HARTZELL PROPELLER INC.

SERVICE BULLETIN

Propellers - Composite Blade Inspection

Figure 1

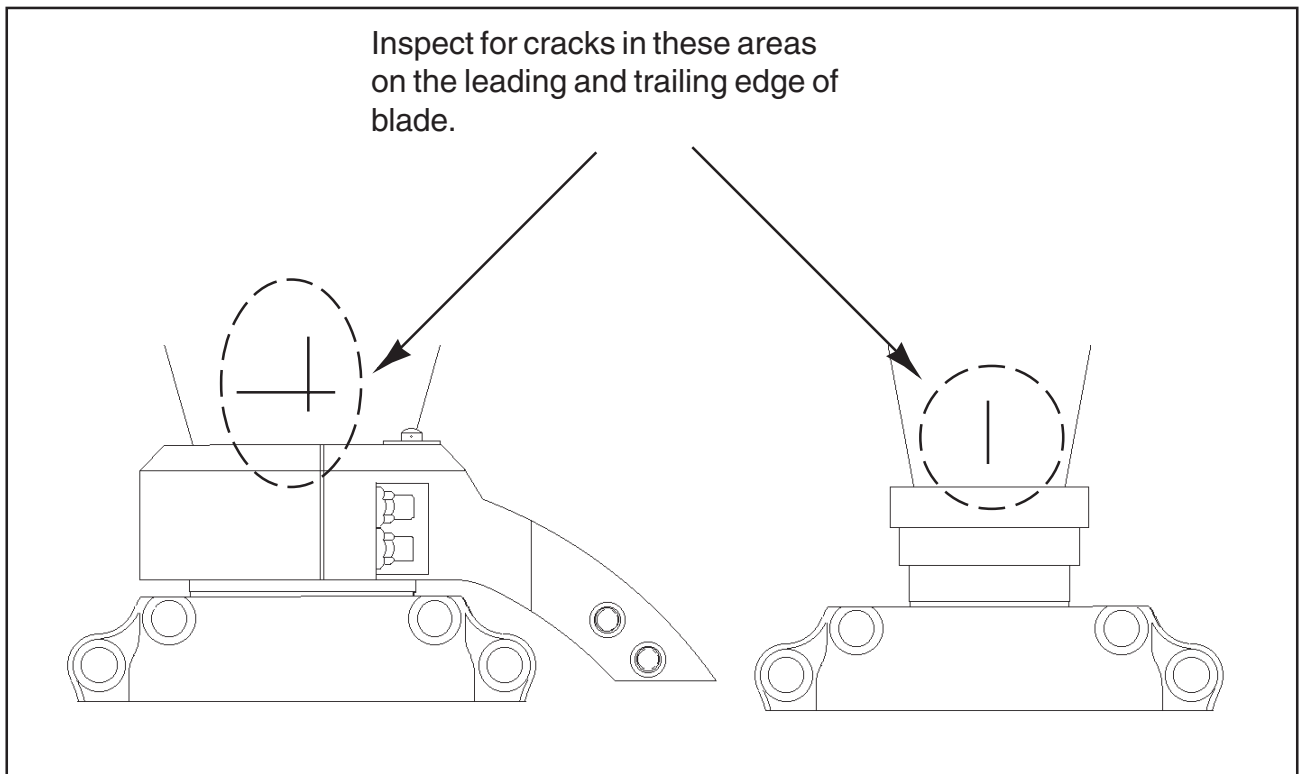
- (1) Remove spinner in accordance with the Propeller Owner's Manual No. 145 (ATA 61-00-45).
- (2) Inspect (on wing) for cracks in the blade shank area as shown in Figure 1. If the blade has counterweights, inspect around the blade shank and counterweight assembly.
- (3) If no cracks are visible, reinstall spinner and make a log book entry indicating compliance with the inspection specified in this Service Bulletin and indicate when the next inspection is due.
- (4) If a crack is present:
 - (a) Disassemble the propeller in accordance with Hartzell Manual 113B.
 - (b) Retire cracked blade(s). Notify Hartzell Propeller Product Support.
 - (c) Reassemble the propeller in accordance with Hartzell Manual 113B.
